1385 HILLSIDE CIRCLE, (LOT 2) BURLINGAME, CA
A.P.N.: 000-000-000

DATE: 10/26/21		
SCALE: AS NOTED		
DRAWN: MC		
FOR:		
SHEET NO. A.1		
NEW RESIDENCE 1385 HILLSIDE BURLINGAME, C.A. A.P.N.: 000-000-000 CIRCLE LOT 2

ARBORIST REPORT

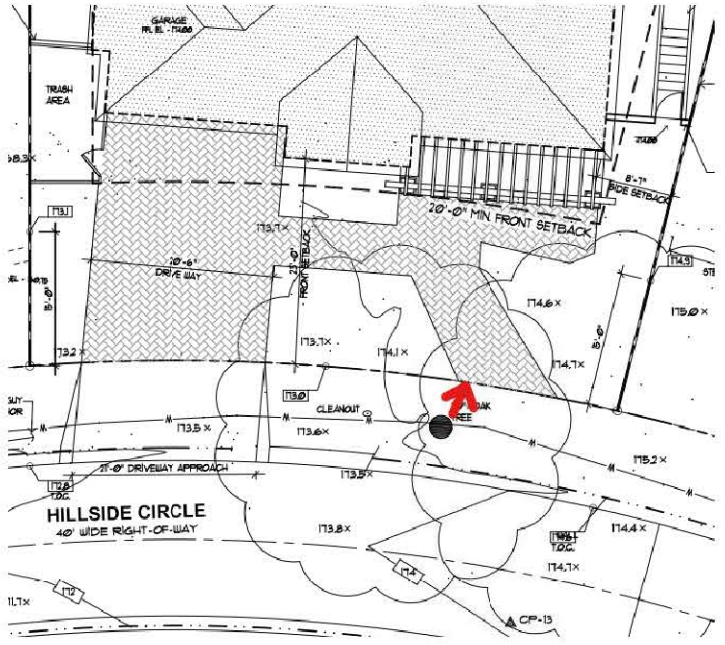
Showing portion of driveway recommended to be retained until the landscape phase of the project.

Plan change needed:
A new pathway is proposed at 4' from oak tree #10. This is too close to the tree and impacts would be expected. It is recommended to maintain a minimal clearance of 10' from the tree to the pathway to keep impacts on the tree low. With this plan change implemented, impacts are expected to be minor and will be mitigated by the recommended deep water fertilizing with Nutriroot.

A new pathway is shown adjacent to valley oak tree #2. It is recommended to have the pathway no closer to the tree than the existing pathway next to the tree. This may result in a plan change. All landscaping work below the dripline of the tree is recommended to be done by hand under the direct supervision of the project arborist. Excavation is recommended not to exceed 6" for any landscaping when underneath the tree's dripline. No roots measuring larger than 1.5" in diameter shall be cut for landscaping purposes. No grading shall also take place underneath the tree's dripline.

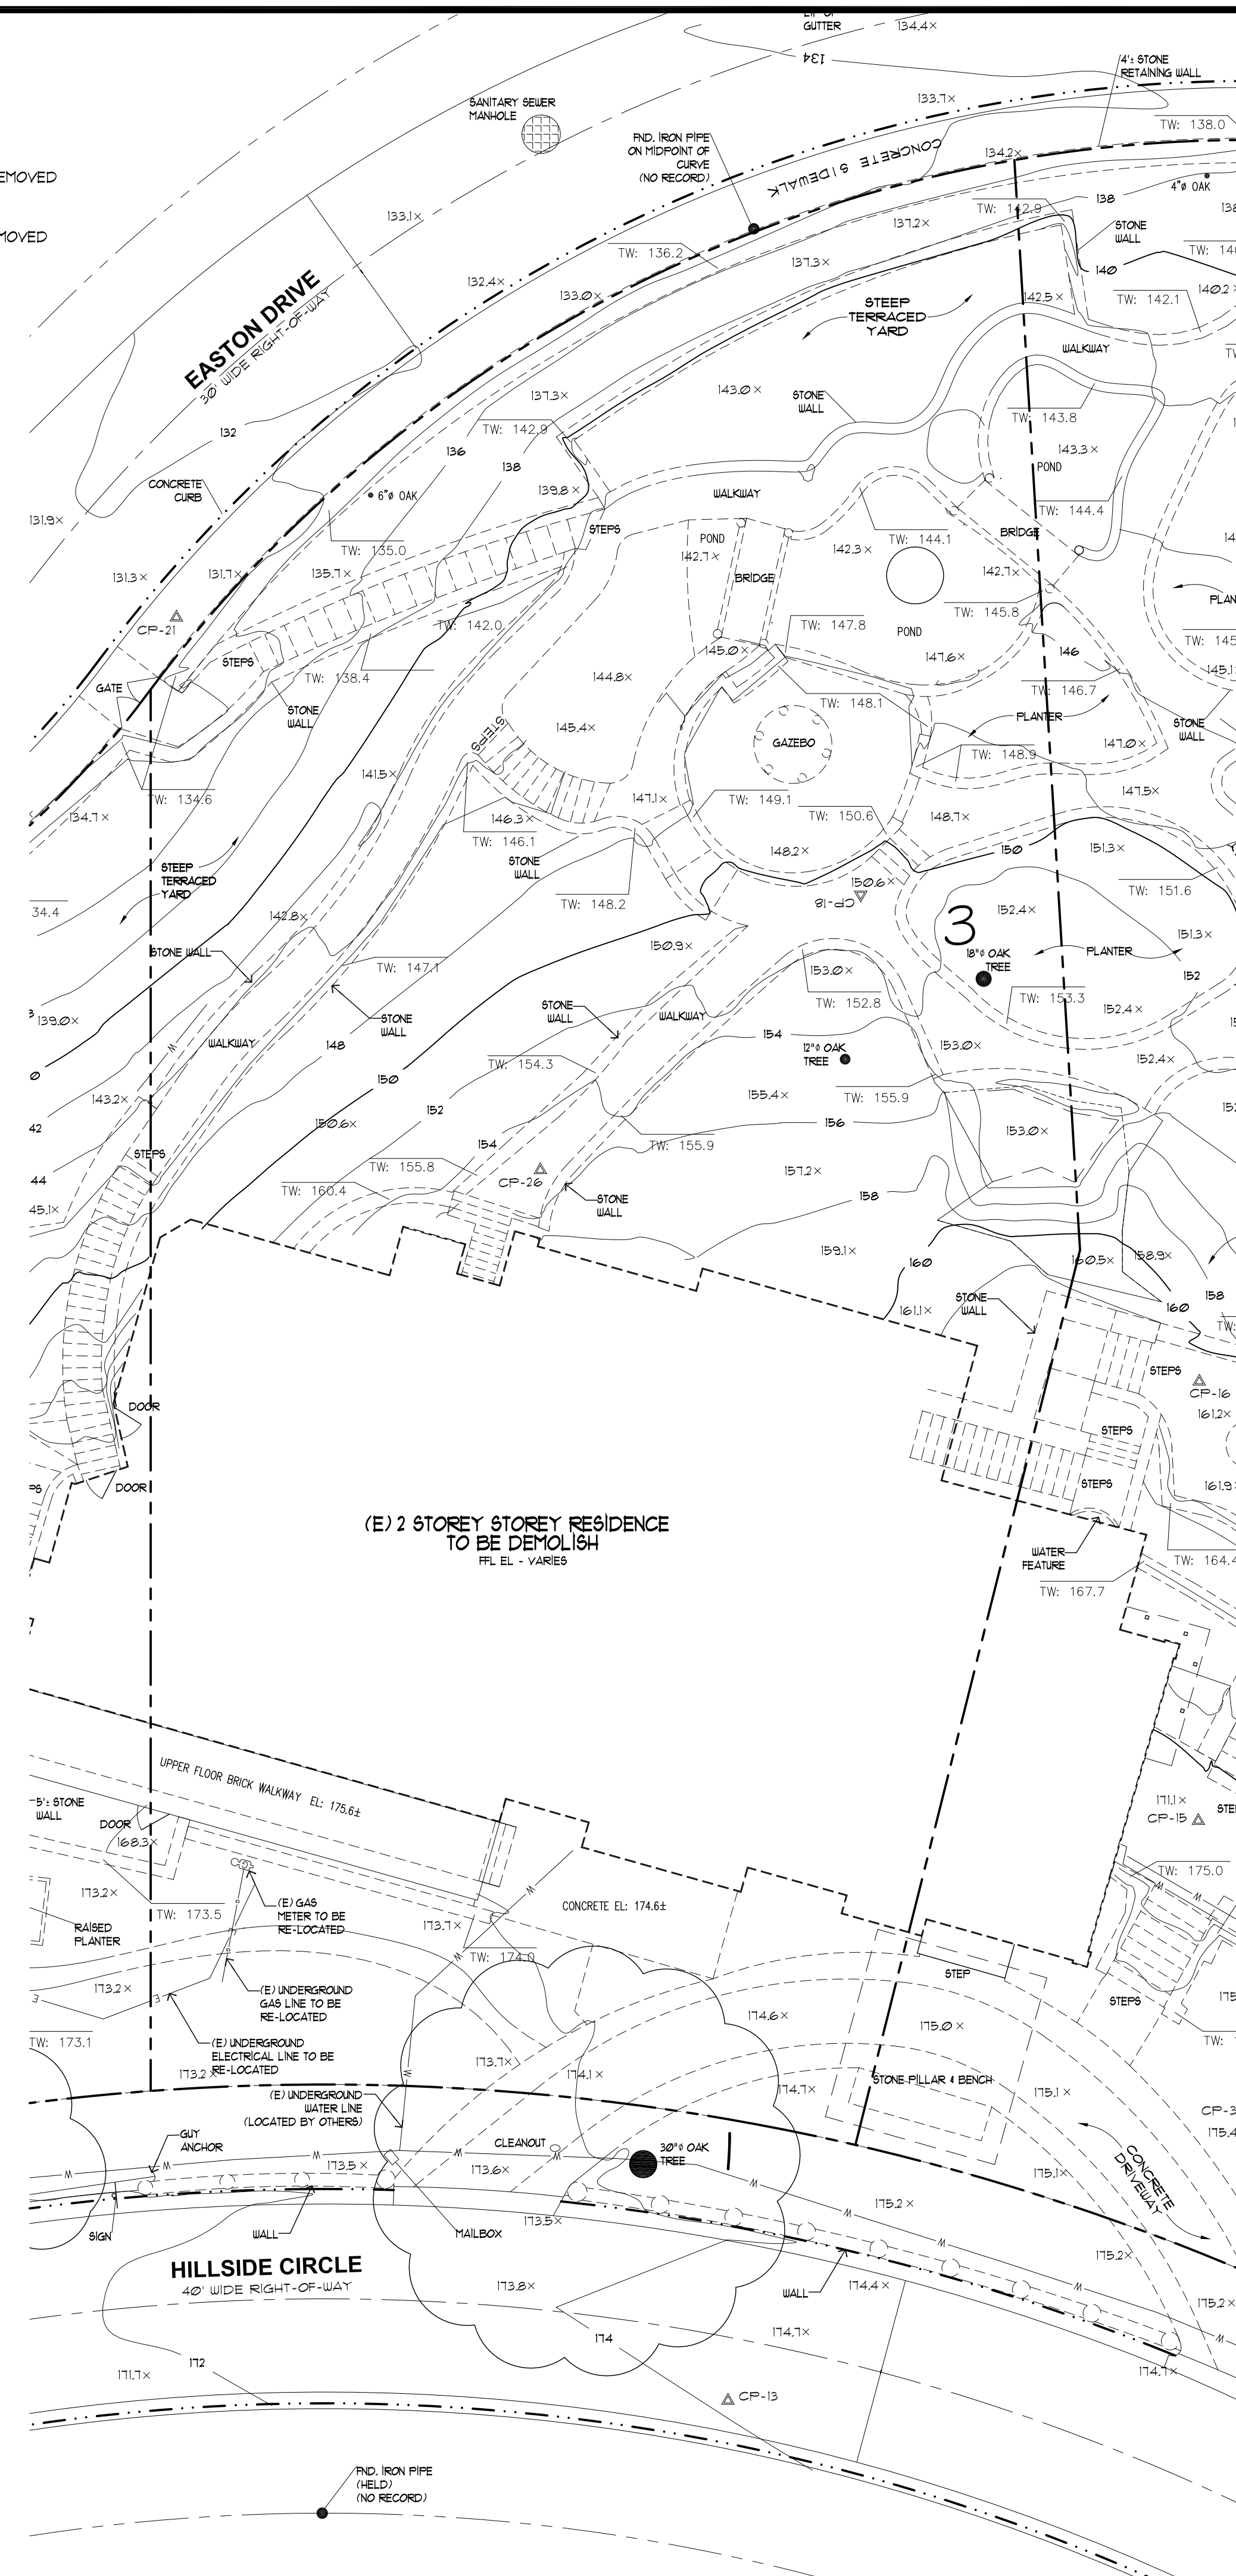
ENSURE THAT TREE PROTECTION SPECIFICATIONS ARE SHOWN GRAPHICALLY ON SITE PLANS FOR CONTRACTOR TO FOLLOW, AS FOLLOWS:

LOCATION OF ALL TREE PROTECTION MEASURES INCLUDING BUT NOT LIMITED TO FENCING, TRUNK WRAP, ROOT BUFFER, ARE TO BE GRAPHICALLY SHOWN ON DEMO PLAN A2 SO THAT CONTRACTOR CAN EASILY INSTALL AND EXECUTE THE TREE PROTECTION MEASURES.

LOCATIONS OF HAND DIGGING AND LOCATIONS OF WORK TO BE UNDER PROJECT ARBORIST SUPERVISION ARE TO BE GRAPHICALLY SHOWN ON THE RELEVANT SITE PLAN SO THAT CONTRACTOR(S) CAN EASILY UNDERSTAND AND EXECUTE THE SPECIFICATIONS. WORK WITH THE PROJECT ARBORIST TO PRODUCE ACCURATE INFORMATION ON THE RELEVANT SITE PLAN. SOME OF THE INFORMATION WILL BE ON THE A SHEETS AND SOME ON THE L SHEETS.

ARBORIST REPORT RECOMMENDS:
RETAINING SOME OF THE DRIVEWAY NEAR TREE 1 AND BREAKING IT DOWN BY HAND LATER IN THE PROJECT. PUT THIS ON DEMO PLAN A2 SO CONTRACTOR CAN FOLLOW IT.
CHANGING THE PATHWAY NEAR TREE 10 TO AVOID ROOT LOSS/DAMAGE. WHERE IS TREE 10 HAS THE PATHWAY BEEN CHANGED?

ARBORIST REPORT IS BASED ON REVIEWING 1 PLANS DATED JAN 2024, LOT 1 A PLANS DATED 10-26-22, LOT 2 A PLANS DATED 10-26-21 AND LOT 3 A PLANS DATED 10-26-21. NO CIVIL PLANS REVIEWED. NOTE THAT THE CONTENT OF CIVIL PLANS MAY NECESSITATE A CHANGE IN THE ARBORIST RECOMMENDATIONS.

PER CHAPTER 11.06, THIS PROJECT REQUIRES 3 SINGLE-TRUNKED LANDSCAPE TREES FOR LOT 3:
TREES MAY BE EXISTING OR NEW

REQUIRED TREES MUST HAVE A MATURE HEIGHT OF OVER 15 FEET

ALL REQUIRED TREES MUST BE IN GOOD CONDITION AT THE FINAL ARBORIST INSPECTION.
STREET TREES DO NOT COUNT TOWARDS THE REQUIRED TOTAL

PROVIDE THE BOTANICAL NAME (GENUS AND SPECIES) AND LOCATION OF THE REQUIRED LANDSCAPE TREES AND WHETHER THEY ARE EXISTING OR NEW, FOR EACH LOT.
